Stantec Consulting Services Inc.  
1060 Andrew Drive, Suite 140  
West Chester PA 19380

July 19, 2022  
File: 213403364

**Reference: Response to Public Comments**  
**Sitewide Remedial Investigation Report Addendum,**  
**Sitewide PADEP Facility ID No. 780190**  
**Former Philadelphia Refinery**  
**3144 Passyunk Avenue**  
**City of Philadelphia**  
**Philadelphia County**

See Proposed Addendum, Figure 13 (page 677 of 1435 in the pdf document)

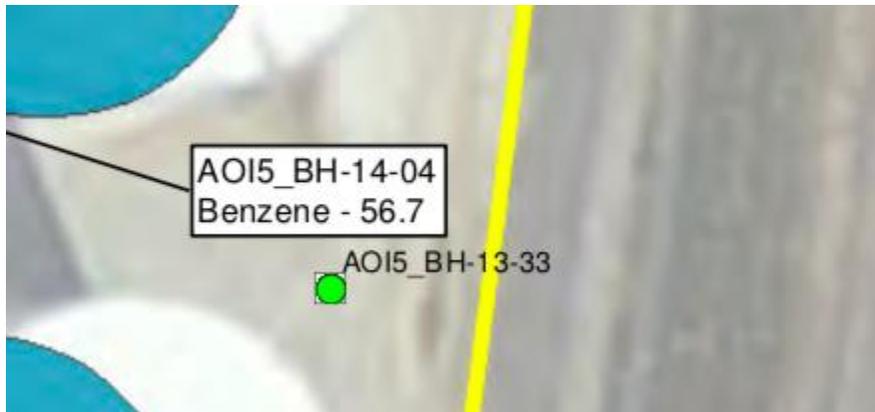
In the following Figure in the Proposed Addendum, Evergreen highlights exceedances of the direct contact numeric value of 1000 mg/kg for lead with orange circles:

With respect to the AOI-5 remedial investigation report in 2017, the Council has counted more than 50 lead samples with concentrations above 1000 mg/kg. See AOI-5 Report, part 1 (January 16, 2017), Table 4, [https://phillyrefinerycleanup.info/wp-content/uploads/2019/02/Philadelphia-Refinery\\_AOI-5-RIR\\_01-16-17\\_Part1.pdf](https://phillyrefinerycleanup.info/wp-content/uploads/2019/02/Philadelphia-Refinery_AOI-5-RIR_01-16-17_Part1.pdf); see also Attachment 1 – AOI-5 Lead samples in excess of NRDC, soil-to-groundwater numeric value, or groundwater MSC (compiled by Clean Air Council). Evergreen’s map in the Proposed Addendum shows only about half of these exceedances.

For example, Evergreen erroneously highlights sample AOI5\_BH-13-33 in green (see below), indicating that it is below the direct contact numeric value:

*See id.* (magnified). The measurement taken on March 7, 2013 was 1090 mg/kg, which is an exceedance.

CAC uses a specific example to assert that "Evergreen has failed to identify a large number of lead exceedances". The figure used as an example on page 13 of the CAC's comment document was included in the Sitewide RIR Addendum as an attachment to an appendix of the report that included previous documentation for completeness. The attachment was included for a different purpose, namely, to show previous investigation information for AOI 5 in support of the additional cumene investigation. The figure is from a response to PADEP comments on the 2017 AOI 5 RIR, and CAC has misinterpreted the meaning of the of the symbols on the figure. This misinterpretation is understandable considering the explanation of the symbols in the legend was ambiguous and there was no text to accompany the figure to provide clarification. To clarify, the symbols on the Figure 13 of the 2017 PADEP comment response letter were assigned the following colors with respect to exceedances: green to indicate "Surface Soil Boring Location with No Exceedance of Sitewide MSCs" and orange to indicate "Surface Soil Boring Location with Exceedance of the Sitewide MSCs". The term "Sitewide MSCs" was not defined on the figure. However, it was a term used by Evergreen consultants to indicate the endpoint of the soil screening process as described in the AOI-specific RIRs (the SSS for lead and the non-residential direct contact MSC for the remainder of compounds). This figure was not attempting to compare lead results to 1,000 mg/kg or 450 mg/kg as CAC has assumed. For comparisons of lead in surface soil to these values, CAC is referred to the figures that were more recently prepared for this express purpose (Sitewide RIR Addendum Figures 2-1 and 2-2). Detailed figures were also provided in Attachment 4 to the August 28, 2021 response to PADEP comments on the March 2021 RIR. On page 15 of CAC's comments, it is suggested that there are errors to these Attachment 4 figures, but CAC does not elaborate.

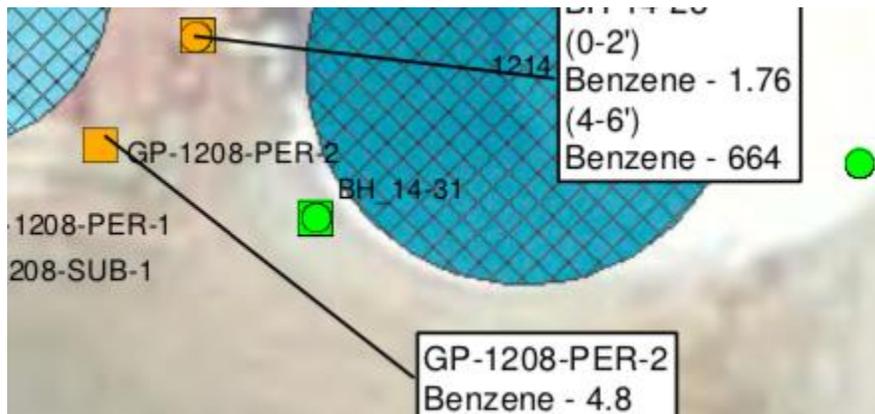
Similarly, Evergreen erroneously highlighted sample Bh\_14-31 in green:

*See id.* (magnified). The measurement from June 19, 2014 was 1980 mg/kg.

Figure 2

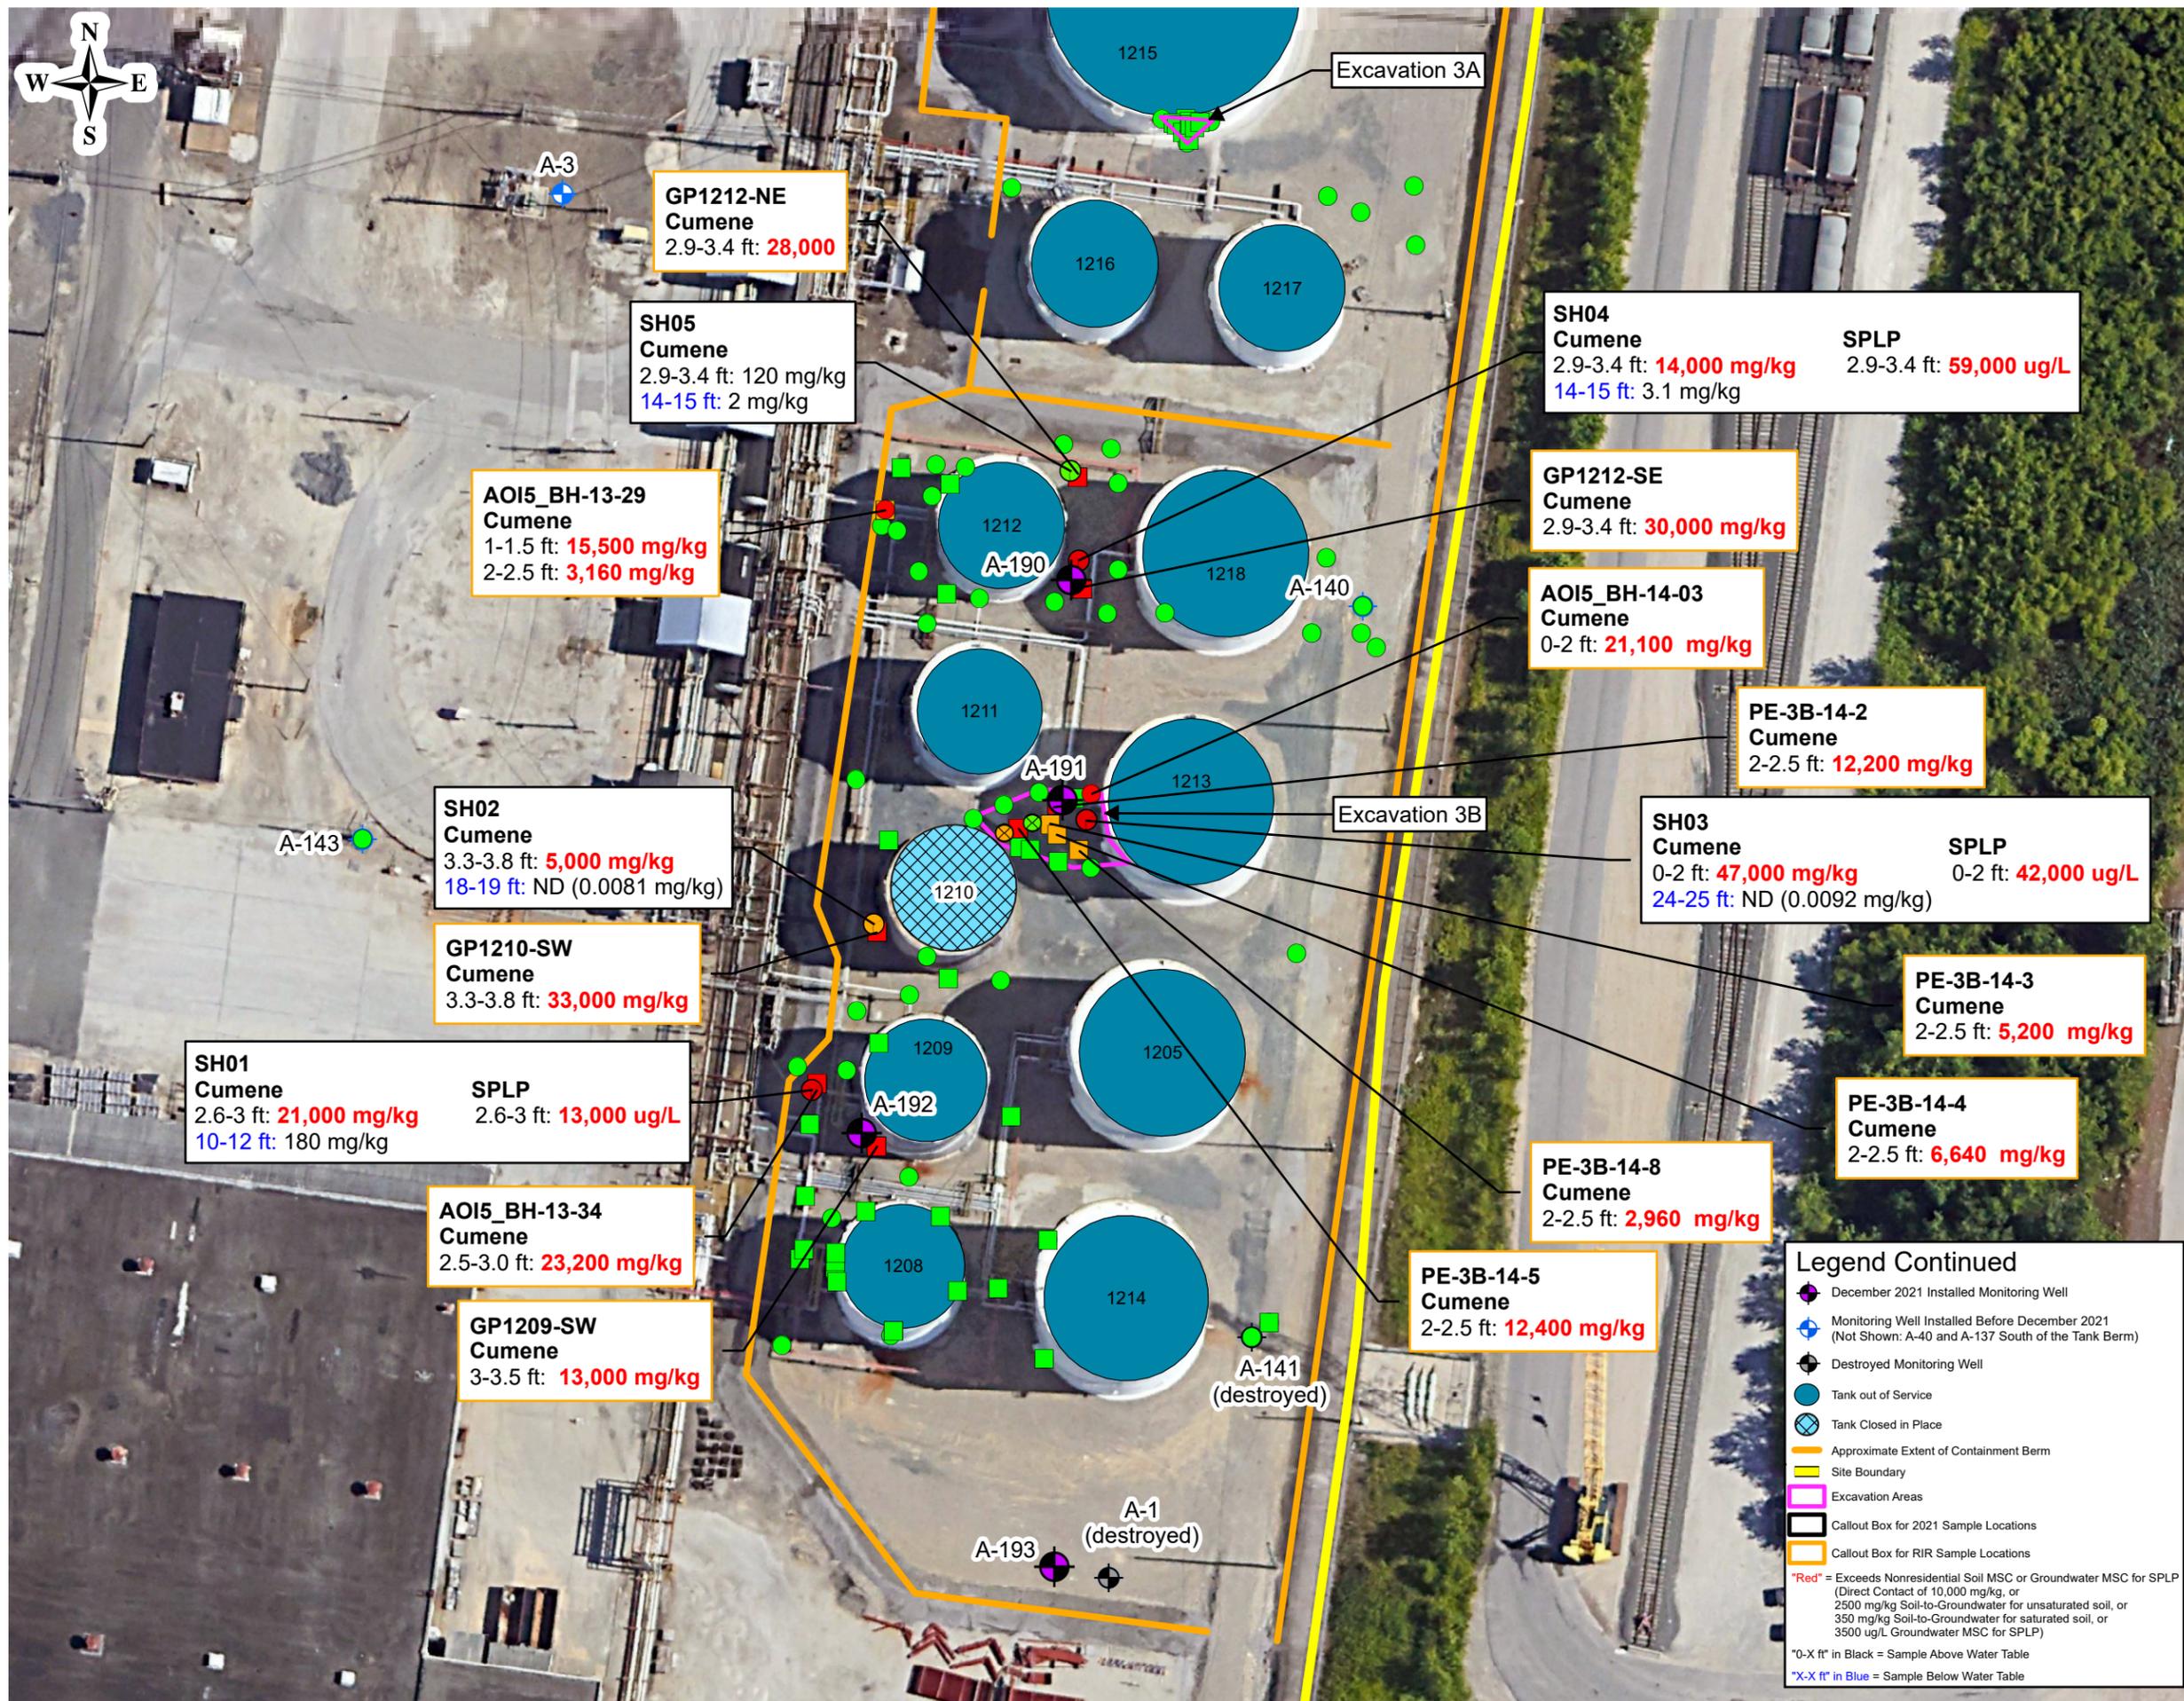
In its investigation of cumene in AOI-5, Evergreen inappropriately relied solely on the direct contact numeric value of 10,000 mg/kg, and failed to delineate contamination according to the soil to groundwater numeric value of 2500 mg/kg, where required by the regulations.

See *id.*, page 132 of the PDF (emphasis added). This was represented visually in the following Figure:

Appendix C of the Sitewide RIR Addendum does discuss soil results with respect to the soil to groundwater value in text Section 4.1, text Section 5.3, Table 3, and Figure 2.

Typically, Evergreen does show soil data compared to the soil to groundwater value on its figures by using different symbol colors. The formatting of this information was different Figure 2 of the Appendix C, and instead showed this information by using color coding for the sample results in text boxes. An updated visual representation of this comparison is provided as **Attachment B** of this response to public comments to provide additional documentation of the comparison to the soil to groundwater value. Additionally, on page 25 of CAC's comments, Table 3 of Appendix C is reproduced with the comment that two samples were not identified as being in exceedance of the soil to groundwater value. However, CAC did not reproduce the notes that were presented on Table 3 in the original document. Note six states that "Orange-shaded values exceed the Soil-to-Groundwater MSC". The two values that CAC references are displayed as orange-shaded values, thereby noting them as exceedances of the soil to groundwater MSC.
